NOTES FROM BRANDONPASS (w/ corrections)
<http://www.areforum.org/forums/showthread.php?t=166659&highlight=brandonpass>

NOTES FROM BRANDONPASS

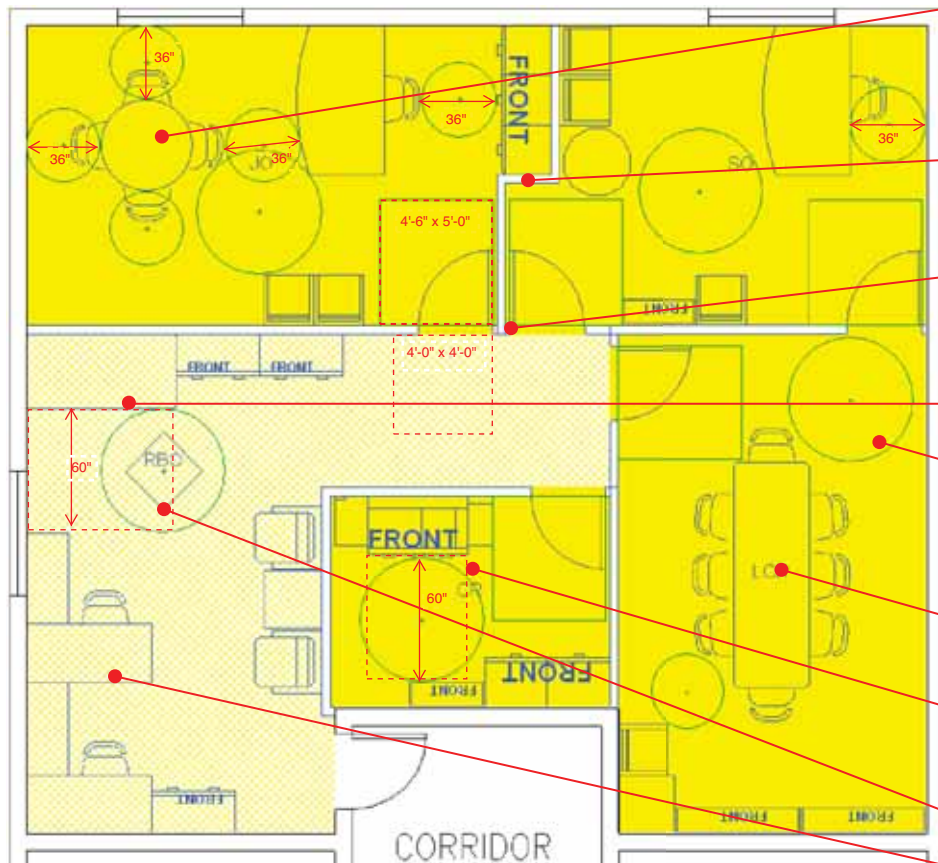
36" clear path: 36" clear between wall and 44" table. 36" clear between two furniture elements. N chair has clear access due to 36" provided between edge of chair and desk. W chair has access via southern route and 36" clear between table chair and arm chair. W edge of table can be 36" to wall since passage around chair is not necessary.

'L' shaped room: nice trick to reduce space in one room for the benefit of the other

All walls are aligning. Simplicity of construction

Doors: place one snap off wall. This will avoid bone headed placement of goods behind the door. Just remove the possibility from even happening. Don't be stupid.

Work Table: 60" clear space at front of the work table. (Ballast p.31)

Clear floor space: since the swing direction of the 2nd door from Smith's office does not matter; place it in his office. Bastard has too much space anyway. This will avoid the overlap of the door swing/clear floor space and the 60" dia turn radius. Although some codes vary on the issue, this will nullify the discrepancy by separating the two.

Conference Room: Maintain 36" clear behind all chairs. However end chairs, one may have a 36" clear between wall and table edge as long as all chairs are accessible via 36" clear path.

Copier room: Placement of the copier allows for the 60" clear in front of copier (Ballast p.31) while preserving the clear floor space for the door and swing. Although some codes vary on the issue, this will nullify the discrepancy by separating the two.

Secretary desk layout: Most efficient & compact layout for the secretarial desks. It is narrower and shorter in length. This example allows direct access to the desk seating from a common circulation space whereas the second example (below) creates a separate 'aisle' which consumes more space. This example also provides for the 60" in front of the work table.

WRONG: inadequate clearance to SW corner chair. There must be 36" clear between the SE chair and the wall to gain access to the SW chair...OR the same can be done for the NW chair to gain access to the SW chair although this would push the NE chair too close to the desk. As a result you would have to move the desk, credenza wall partition, SO seating and desk. there is room behind the SO desk so this would probably work although time consuming.

PUSHING IT: discrepancies exist between study materials and forum dwellers on this issue. 36" vs 60" at front of work table. This particular example is a result of an inefficient secretary desk layout.]]

Secretary Desk: this layout although acceptable, takes up way too much space compared to the above example. A separate space is created, the width and length are substantially larger and as a result, create a tight path relative to the lounge seating and does not allow for 60" in front of the work table. Also, look at that stray file cabinet? What a dog! Again, it works but damn that's shitty design.

'L' Shaped Room: A nice trick to recess the bookshelves. Be aware of the door clearance space. Such a move could result in a serious time consuming trickle effect if you don't know what the hell your doing. I.E.: *place shelves, move door up, move 'SO' office wall up, have to move arm chairs, 'SO' door clearance is compromised, move West wall, pinch 'JO' office etc, etc.. Next thing you know, there's five minutes left and you completely botched a passing solution for the sake of built-ins.* Moral of the story...do it early or not at all and practice it. Sweet move when you know where it has to be.

1: **NO** 2: **YES** 3: **YES**

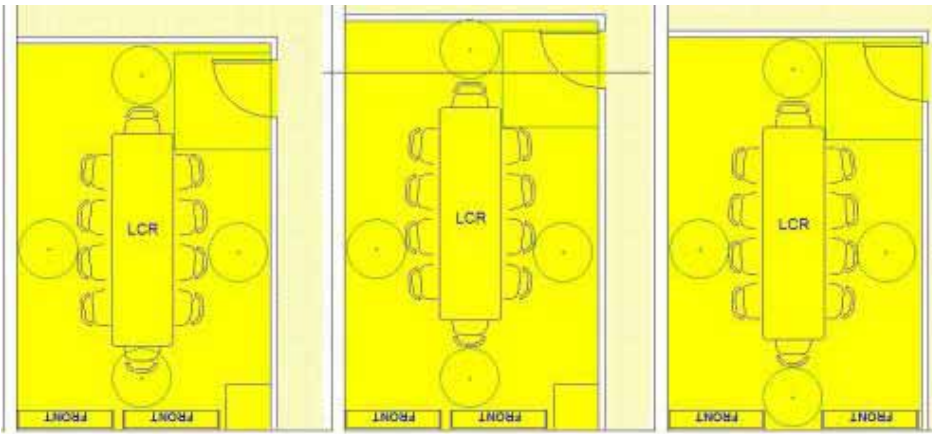
PUSHING IT: Although acceptable, the arm chair relative to the end conference table seat does not allow for 36" passage. 36" clear does exist between the arm and the table edge and the seat is accessible from a clear path via the East of the table but still... not very smart or efficient.

1: Wrong because there is not a clear 36" path between two furniture elements. If there were no bookshelves in this scenario (edge of shelves were where wall would be) then it would be acceptable. See example below

2: Correct because clear 36" path all around.

3: Correct because there is a clear 36" path around table and directly to the Southern most chair. See flow diagram on next page.

4: **NO** 5: **YES** 6: **YES**

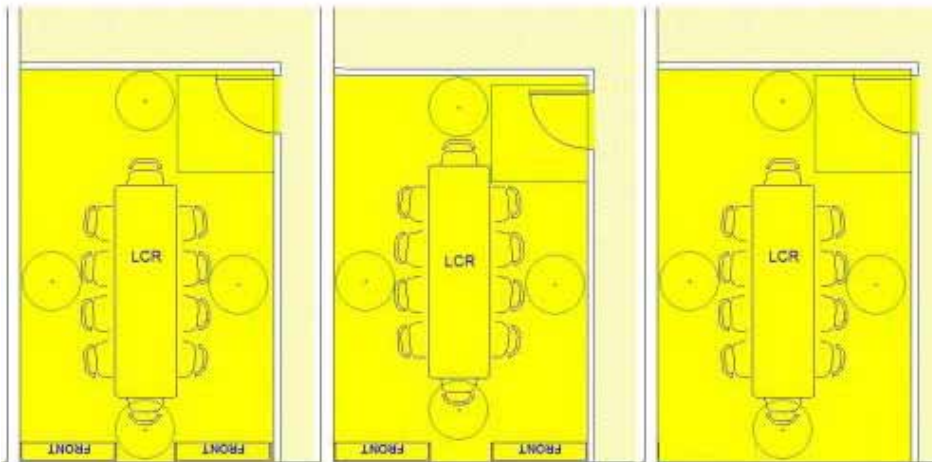
4: Wrong because there is not a continuous 36" path to the Southern most chair.

5: Correct because there is a clear 36" path around table and directly to the Southern most chair. See flow diagram on next page.

6: Correct because there is a clear 36" path around table and directly to the Southern most chair. See flow diagram on next page.

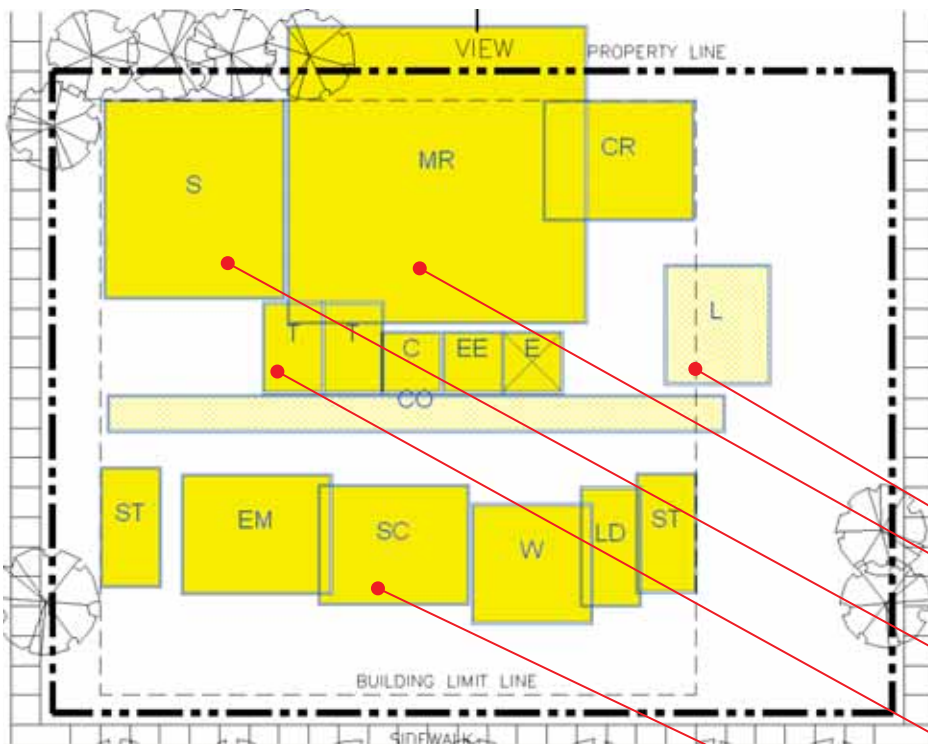
LEFT: Acceptable since there is a clear path around the table of 36" and the southern table is accessible via 36" path unobstructed. See flow diagram next page

RIGHT: See comments for #6 above

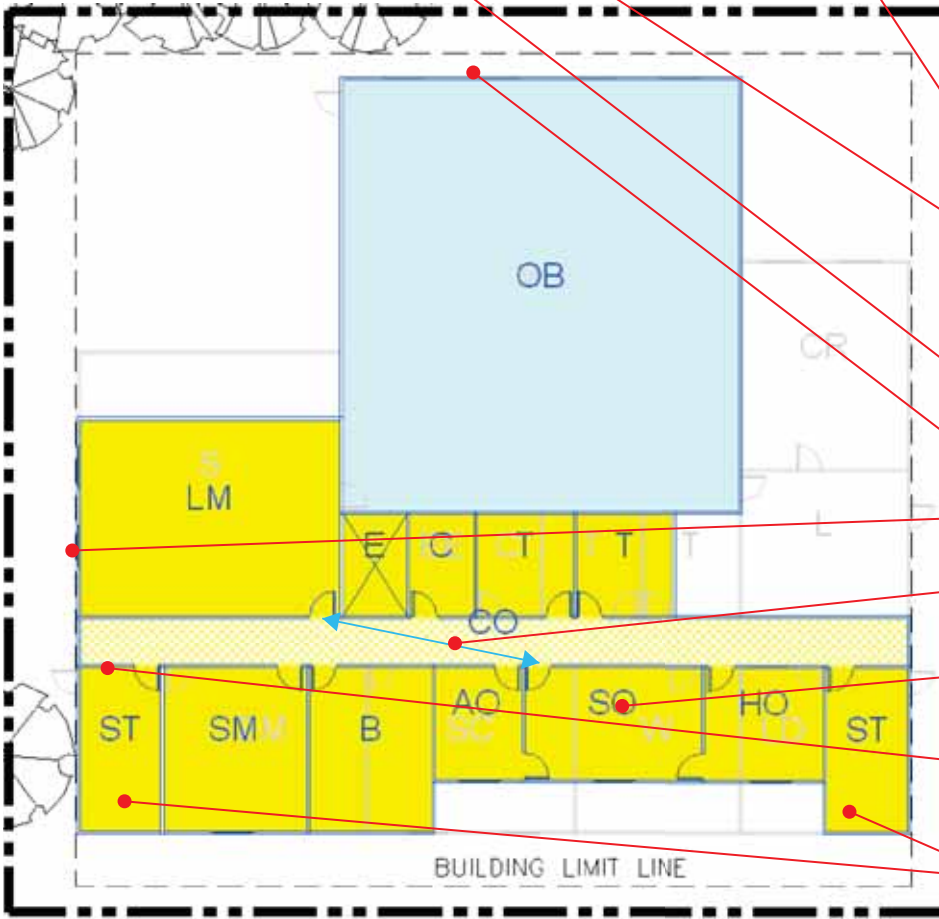
Windows: use sizes between 4'-0" to 10'-0" and make a judgement call on quantity for the space being served. No window is required at the 'Open to Below (OB) volume at the second level.

Egress: Be careful to swing all doors in the direction of travel that are to be used as exits.

There is **no square footage trigger** to add an additional egress door for larger spaces. It will be dictated in the program requirements or inherent to particular spaces. I.E. Lobby/entry (L) and stairs (ST). Double doors only if required by program. We have not been asked to calculate egress factors.

Two means of exiting the larger space, be sure that the exit doors are **no closer than 1/2 of the diagonal distance of that space**. In other words, if you have them at opposite corners as shown here you are twice the minimum and thus, golden.

Nesting: Similar type functions of smaller size work well together. When compared to the previous page 'process', I have elongated all the spaces in the N-S direction. This is because when I rotated the toilet spaces to match the 10' dimension of the elevator and custodian spaces, it extended beyond the West edge of the Main Reading (MR). I didn't like the prospect of an 'L' shaped stack (S) room nor the effects it may have on the second level. Therefore I decided to tweak every space to be congruent with that nice square(ish) reading room and result in an nice square(ish) stack space. Also, I flipped the Elevator to the West as well. Since this is only a two story space and the elevator is not a primary means of circulation but rather an accessibility concern, I relocated it to the corridor for similar 'L' concerns and also when the elevator machine room is removed from that ban of spaces on the second level, there was nothing that could fill the void. It all could still work, but I like to keep my toilet locations relative to each other although not a concern on the exam. Just makes sense. See the next page example to see all this crap in action.

Wall openings: NOT for visual control or direct access. It is only to delete the common wall between lobby & corridor or corridor & corridor. It is meant to adjoin circulation spaces.

No wall opening is required at the elevator shafts

Visual Control: Achieved only with windows...even at the interior partitions. The 'visual control' is to watch door access to the space required in the program. NOT just a view of that box. It may provide control of either side of the door operation as shown between the work space and the lending desk. Here, the LD is watching the door from the W's inside.

Direct access: achieved only with doors... NOT wall openings

Exiting: No door is required at the end of the corridor: Existing is allowed THRU the stairwell from the corridor from the ground level. However; be sure not to pull a Sunny Bono on that tree there. Could probably move the whole building North a bit to take care of this. Also be careful of the **dead-end corridor**. 20'-0" max.

Door swings may extend over building setback lines but not over property lines.

No windows are required at the 'Open to below' space

Windows are allowed at trees but only if deciduous. As with Site Planning, conifers will block the view.

Near: If a door is programmed to be 'near' another space, make sure it is within 1/2 that floors length. NOT 5' - 10' as proposed within the forum, nor 20% as with Site Planning.

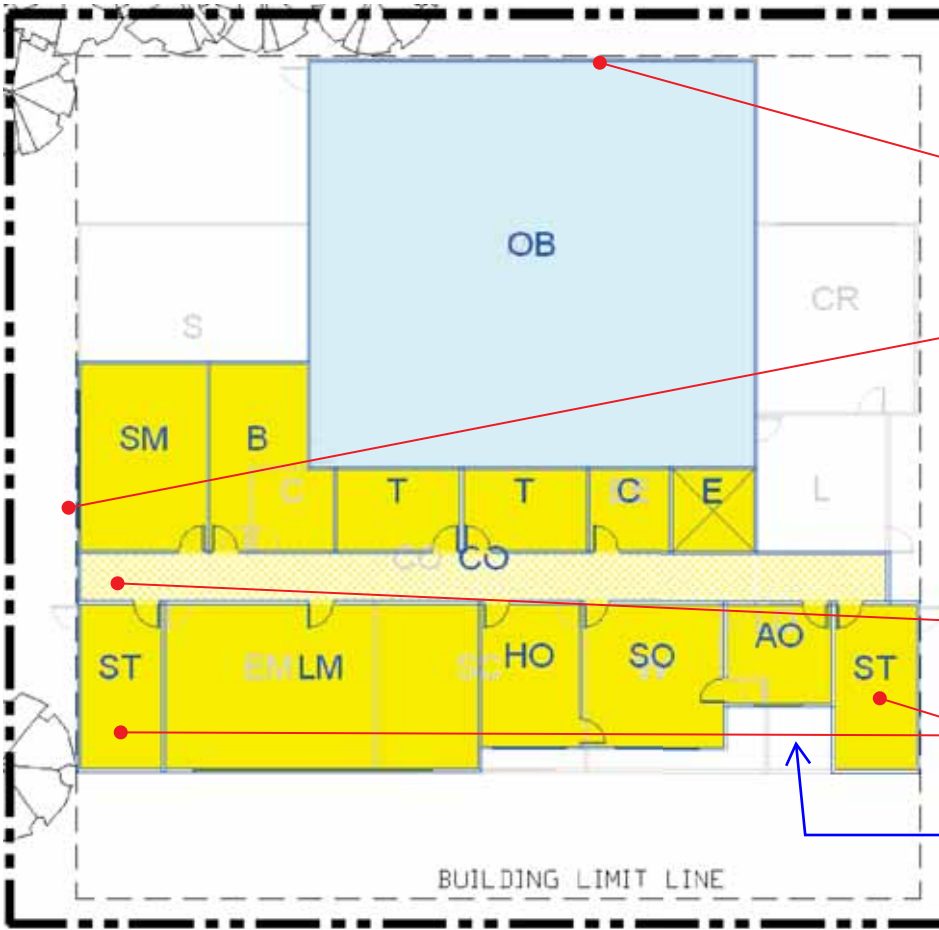
As a result of the comments on the previous sheet, you can see what happens if you just leave the spaces per your perfect 'obvious' dimensions. Some tweaking may be in order to make this baby sing. As is, you get a nasty 'L' shaped stack room (S) which may be acceptable since a larger space, but look at that break room (B) on the second level. Not good.

Stair: As dashed, the stair tower at this end could probably be moved to get rid of that nugget of unused corridor. Remember, exiting can be thru a stairwell. However, not advisable for the East stair for comments below.

In this example, the corridor stops at the lobby. The previous example shows the corridor extending the full length with the lobby (L) set above it. By doing this you gain a bit more length to the lobby for whatever purpose you may need...may make access to some other doors easier. And as far as both of these examples are concerned we are no where near the 25' of the total square footage cutoff point.

Visual Control: For view of doors, not boxes. As shown, the main entry door may be getting to an oblique angle and not as 'visible from the loan desk (LD). Also, if the stair is nudged North as suggested for the West stair, it may block views of the entry entirely.

Would be better to move LD door to East to gain better 'visual' angle of the doors needing control. Also, if you refer to the previous example, by doing so, the door into LD does not block the window for 'visual' of the workspace door.

'L' shaped rooms at this small size is a BAD idea.

There is **no square footage trigger** to add an additional egress door for larger spaces. It will be dictated in the program requirements or inherent to particular spaces. I.E. Lobby/entry (L) and stairs (ST).

Exiting: No door is required at the end of the corridor. Existing is allowed THRU the stairwell from the corridor from the ground level. However, be sure not to pull a Sunny Bono on that tree there. Also be careful of the **dead-end corridor**. 20'-0" max.

Dead end corridors: although not dead ends here, could probably tighten up a bit by pulling back to just outside the door at both ends of the 2nd floor corridor and the West end of the 1st floor corridor.

Stair towers: place in exact same location as those on the ground level.

Keep exterior recesses (niches) w/in 2:1 ratio. This falls under the "sound design logic" category
